PLANNING COMMISSION AGENDA
CITY HALL AUDITORIUM, 250 NORTH 5TH STREET
TUESDAY, FEBRUARY 25, 2020 @ 6:00 PM

GRAND JUNCTION PLANNING COMMISSION
February 11, 2020 MINUTES
6:00 p.m.

MAGNUS CT.
SUBDIVISION

Figure 15: Design Year Total Traffic (2040) (35% NB, 65% SB)

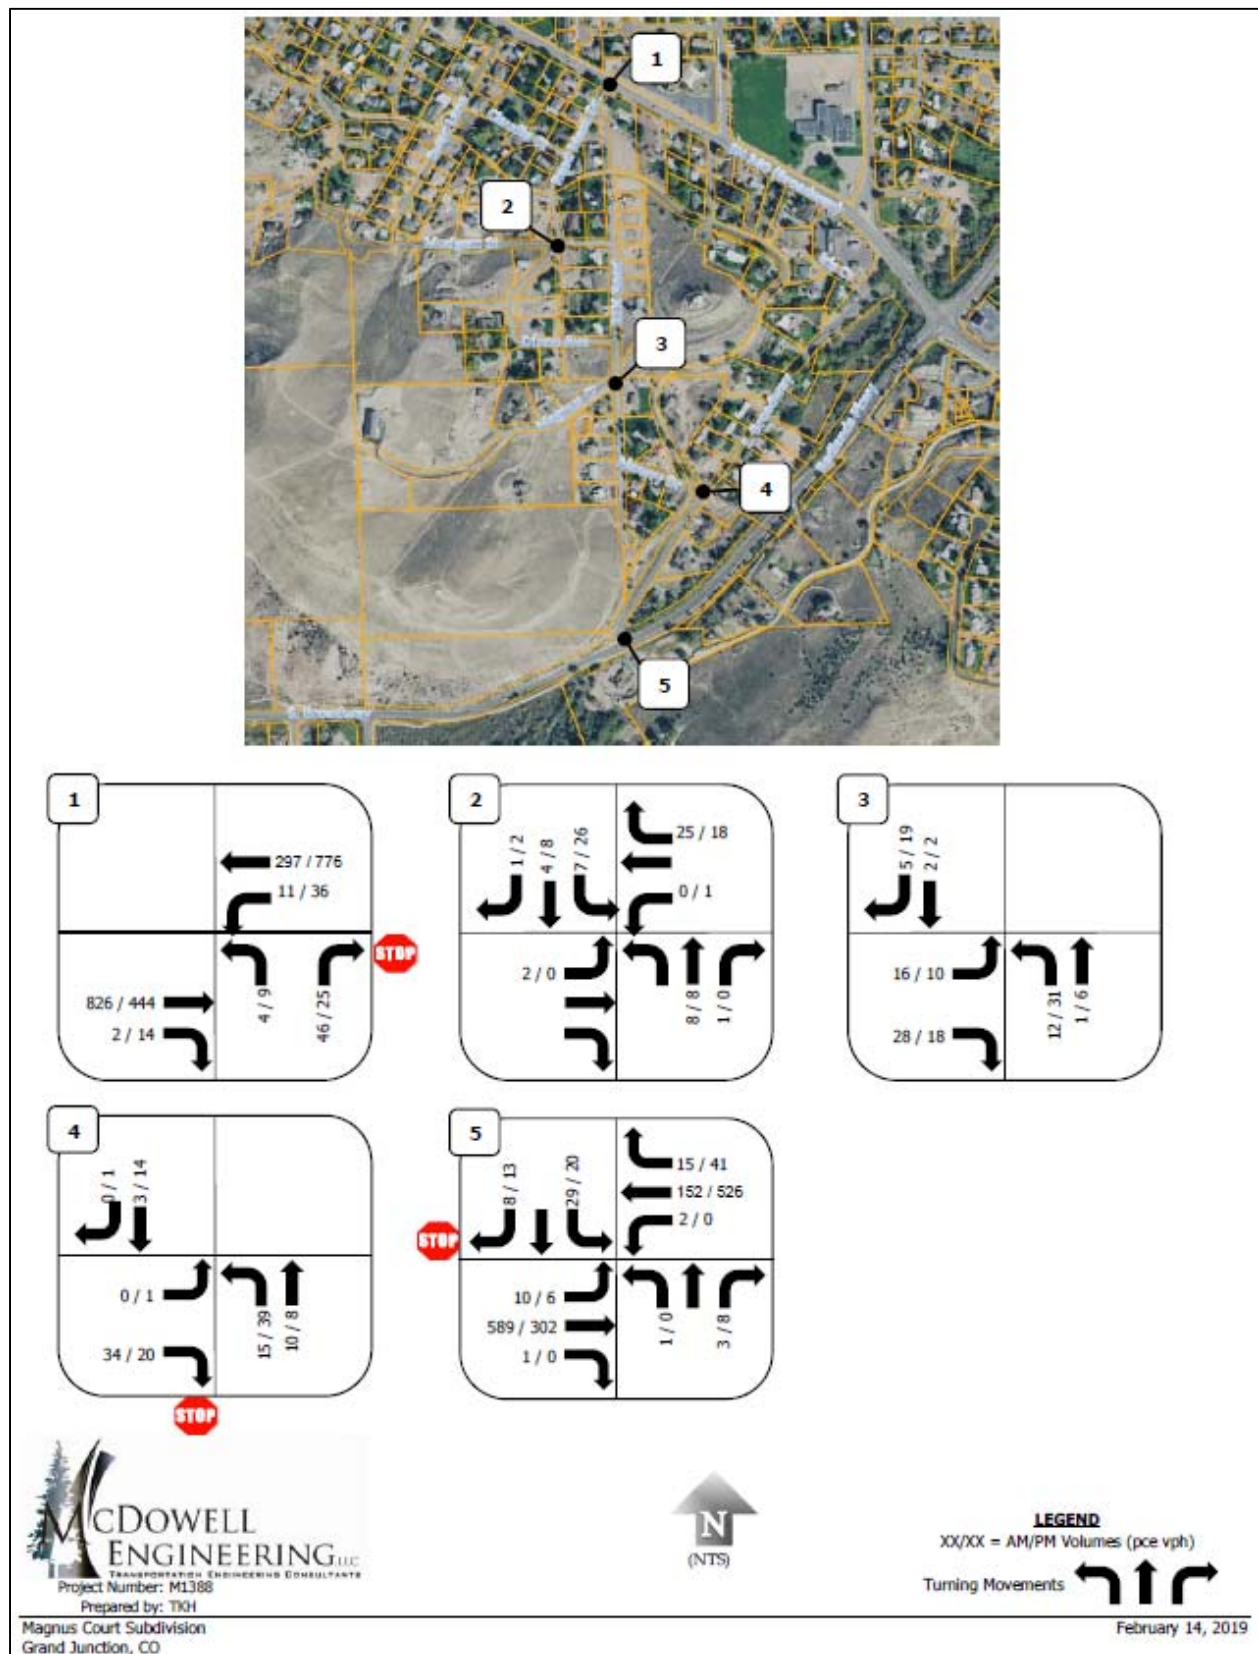
3. It appears that the numbers used in the 2040 BG AM analysis don't match those shown in Figure 15. **The numbers used in the 2040 BG AM analysis should be from Figure 6.**

EXHIBIT A – OUTLINE DEVELOPMENT PLAN

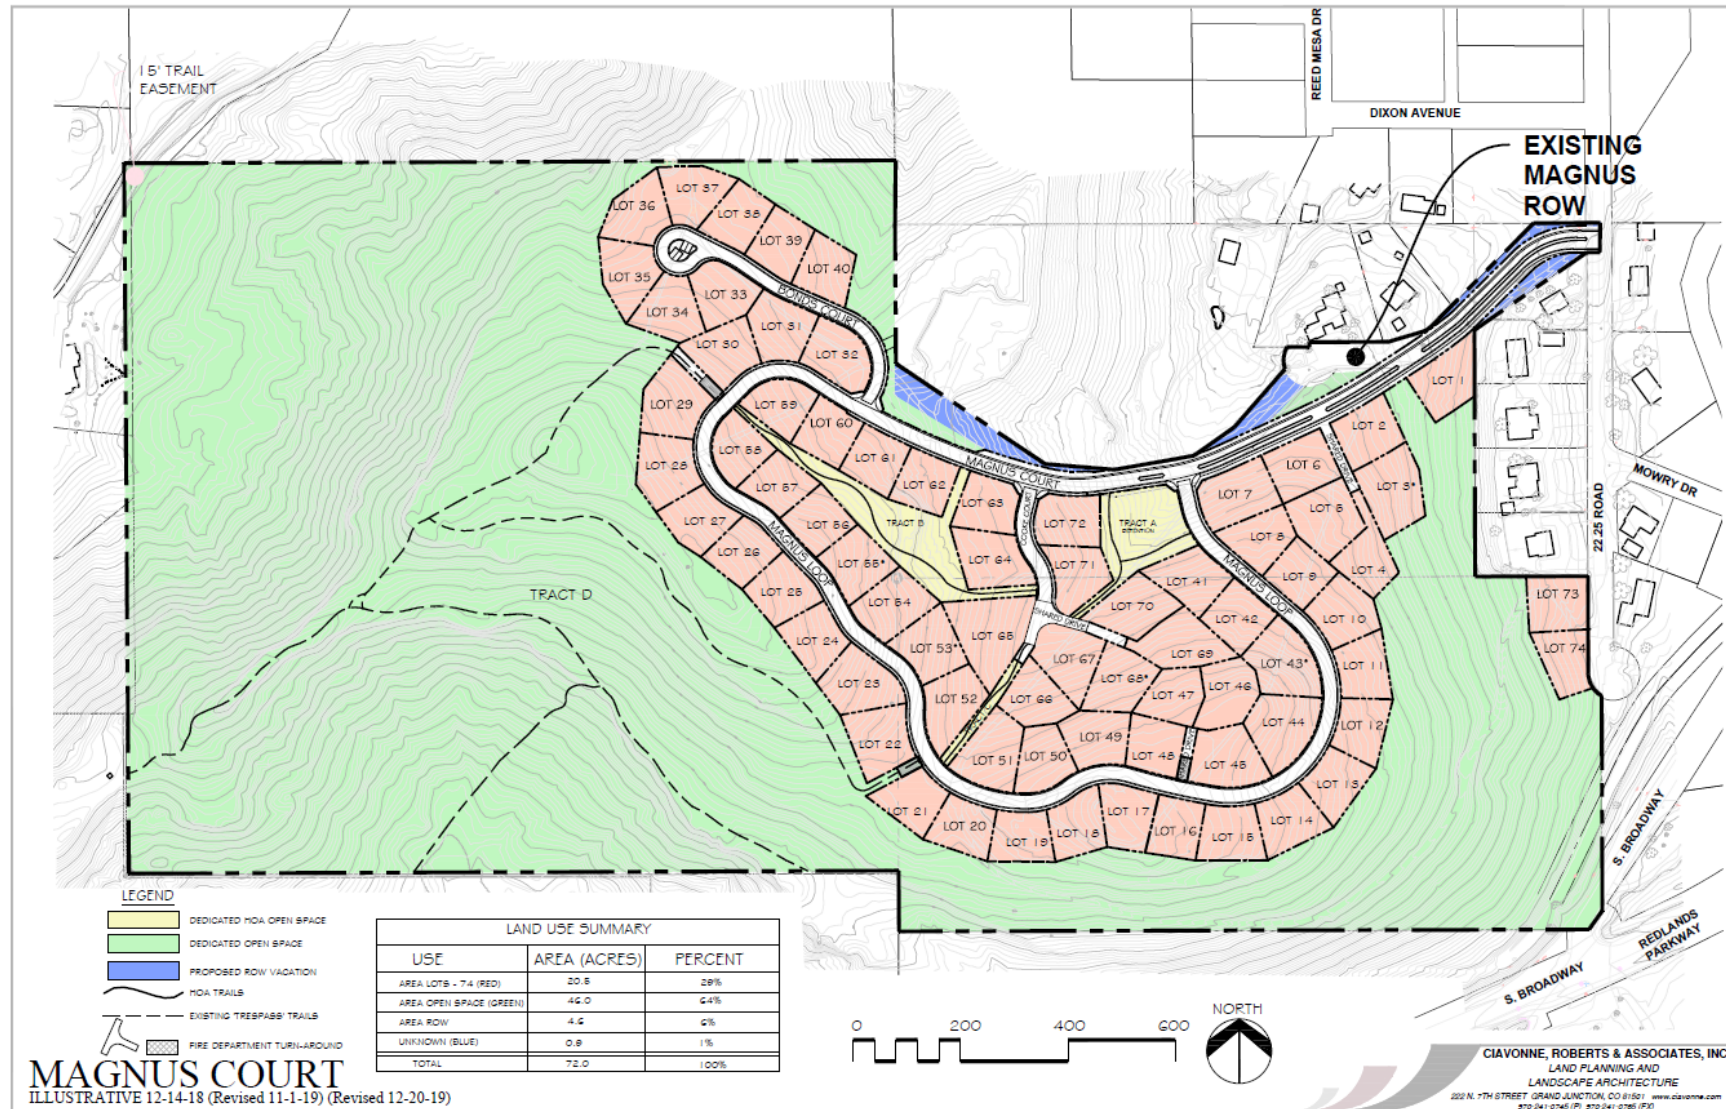
- i. Sheet 1-1 indicates Pods, A, B & C, however, no pods appear on drawing. Revise as necessary. **Reference to Pods omitted.**
 - j. Revise Table 1 and other text on Sheet 1-1 to the correct Default Zone District of R-2 (or discuss further with City Project Manager proposed default zone options). **We have incorporate R-2 as the Default Zone, but are using the R-8 bulk standards per the Cluster Provisions of the code.**
 - k. Revise Table 2 on Sheet 1-1 to identify land uses that would be allowed for the subdivision, such as single-family detached, etc. **Table revised to only allow detached single family.**
 - l. Revise Phasing Schedule on Sheet 1-1 to the correct date of completion. City Manager suggests that the year 2020 be utilized for Phase 1 and so on.
- Code Reference: V-14 of the SSIDS Manual.
- Applicant's Response: Table Revised**
- Document Reference: ODP – Sheet 1-1**

3. On the Outline Development Plan, Sheet 1-1, General Note 2 states: "This PD zone will have default zone, R-2 with R-8 Cluster provision standards." Isn't that backwards? Shouldn't it be R-2 Cluster with R-8 as the default zone? That is what Table 1 shows.

4. On the Outline Development Plan, Sheet 1-1, Table 3 is overlaid on Table 1. Please rearrange data in Table 2 so that OPEN SPACE info is under Table 2 to allow you to bring Table 3 and ROAD STANDARDS lower on the page.

1. Thank you for fixing Magnus Court and Magnus Loop. That is what I meant.
2. Thank you for the street names for the cul-de-sacs. Bonds Court and Cooke Court are acceptable road names. I appreciate that you have provided those for me.
3. Cluster statement: Thank you for clarifying that for me.
4. Thank you for making adjustments on Sheet 1-1. It is much better.
